SUBJECT: Forwards revised responses to Questions 2, 6 & 7 re replacement of spent fuel racks, per NRC 870716 request for addl info & subsequent discussions w/util.

L-87-537

Re: St. Lucie Unit 1
Docket No. 50-335
Spent Fuel Rerack

By letter dated July 16, 1987 (E. G. Tourigny to C. O. Woody) the NRC Staff requested additional information in the area of plant systems it needed to continue its review of this proposed license amendment. By letters L-87-374, dated September 8, 1987, and L-87-419, dated October 19, 1987, FPL submitted responses to this request. As a result of subsequent discussions with the NRC, it was determined that FPL's responses to questions 2, 6, and 7 would need to be revised. Attached are FPL's revised responses.

FIGURE 1 (REV 1)

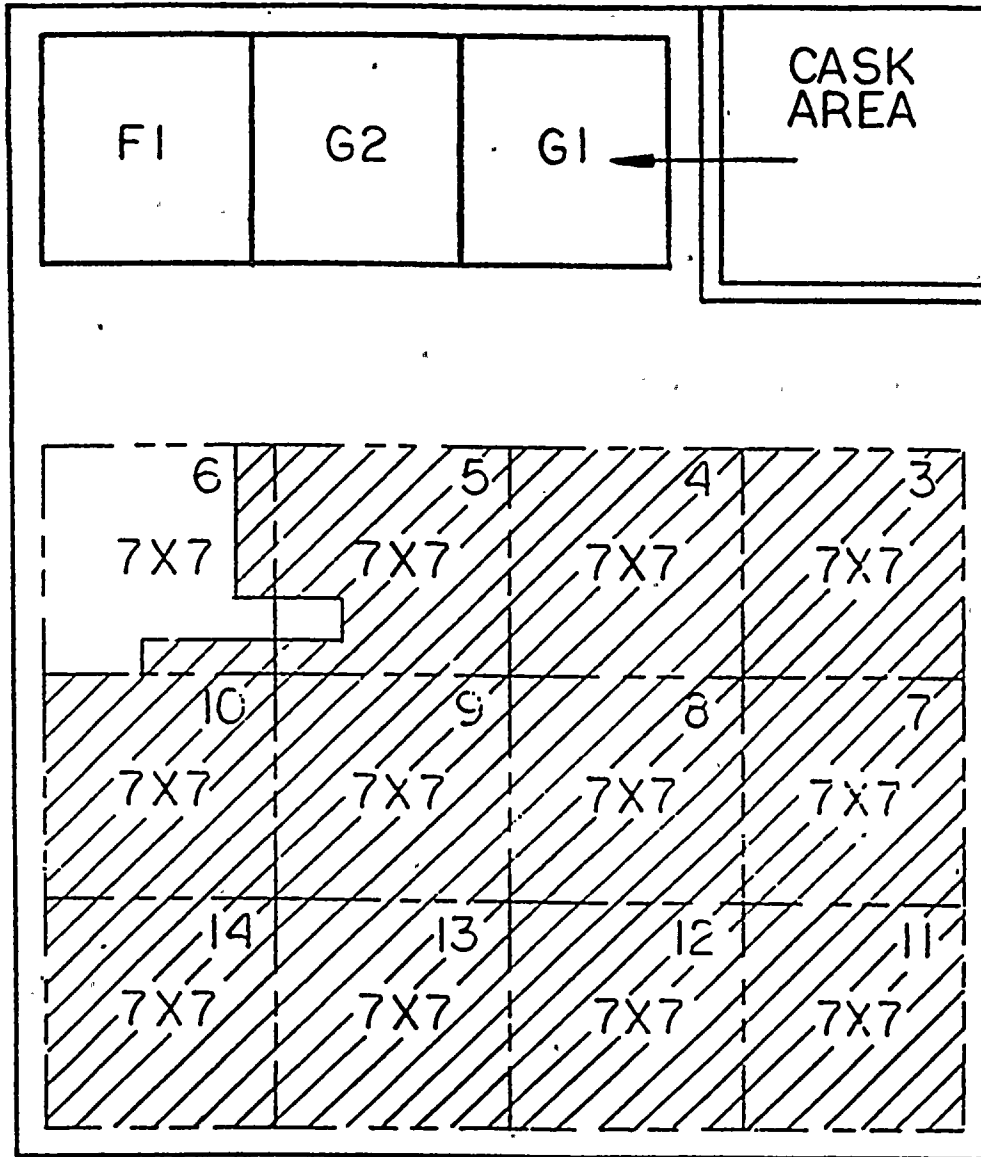
QUESTION: For each step in the replacement of the racks, provide drawings which show the location of the spent fuel and the movement of the fuel which demonstrates that no heavy load will be carried over spent fuel or over any rack which contains spent fuel. (Note: This information can be placed on the set of drawings provided in response to question 5).

1. Relocate all the fuel assemblies presently stored in existing Racks 1 and 2. Following the removal plan (see Question #5), remove Racks 1 and 2 from the pool as shown in Figure 1.
